City of Puyallup
Development & Permitting Services
ISSUED PERMIT

TACO TIME PUYALLUP

1115 EAST MAIN STREET PUYALLUP, WA 98372 PERMIT SET - 7.1.2022

1 SITE PLAN
1" = 20'-0"

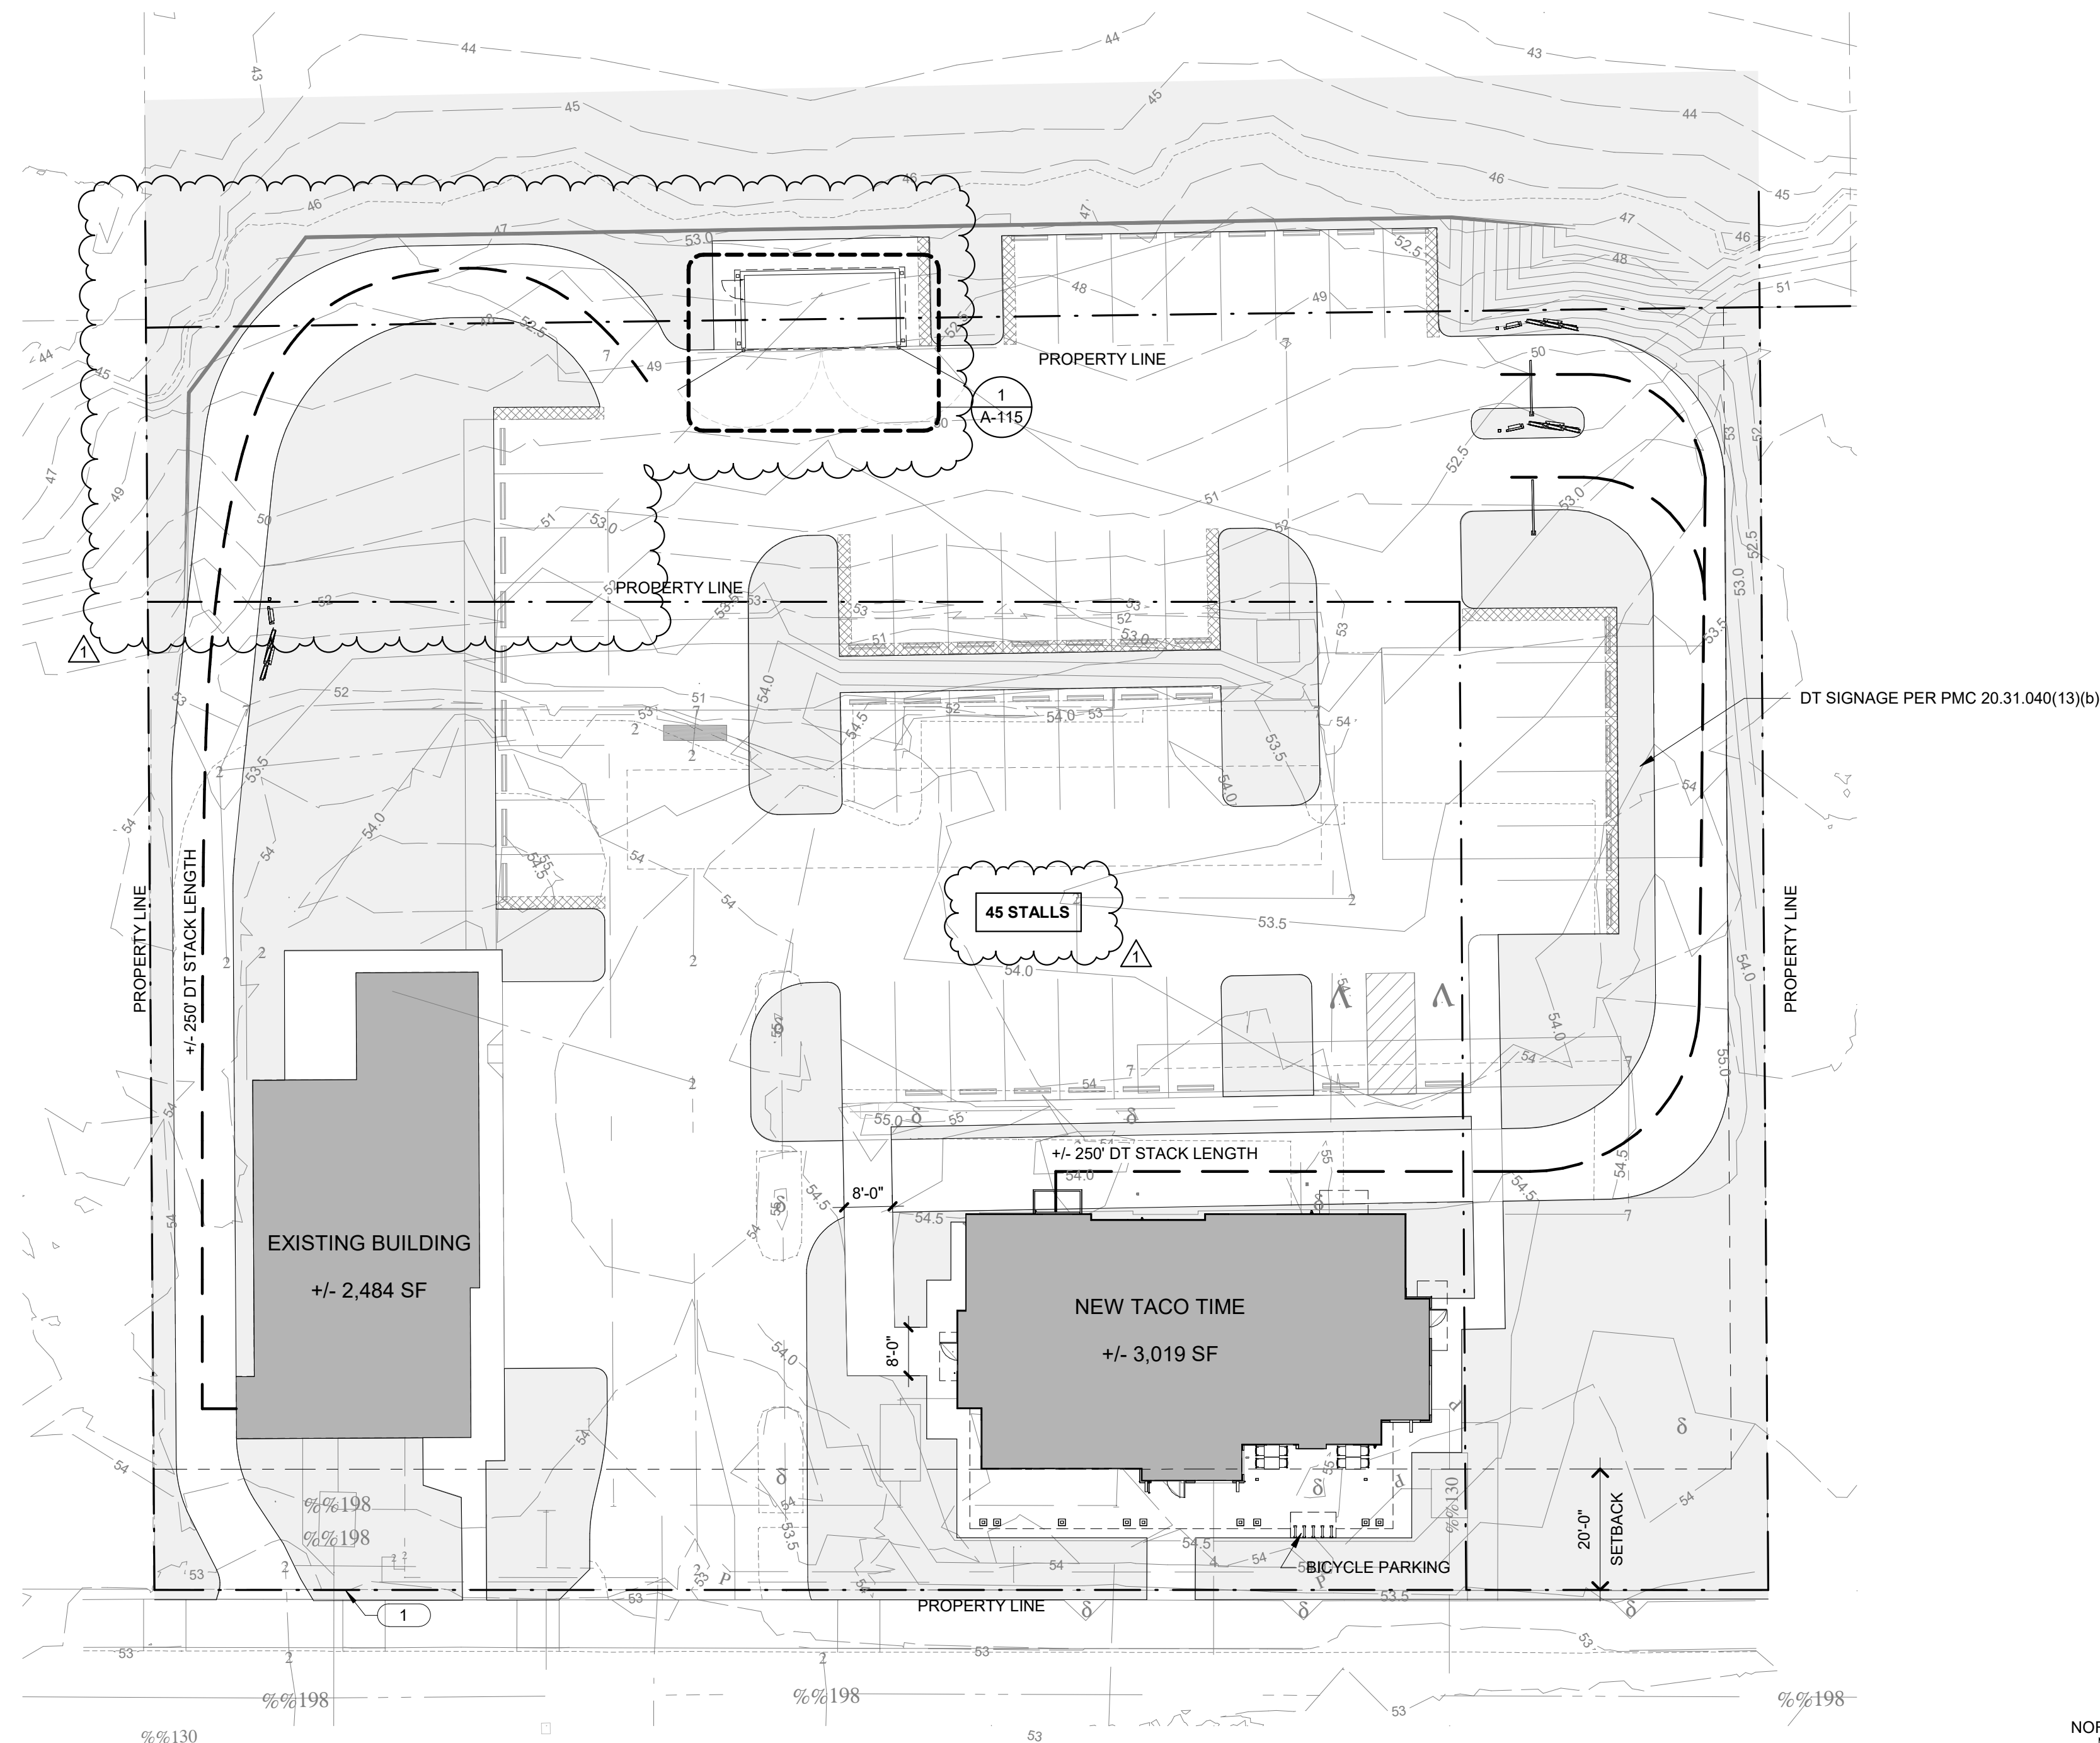
Please dimension set backs from property lines. See plan C-6

The proposed retaining wall requires a separate building permit
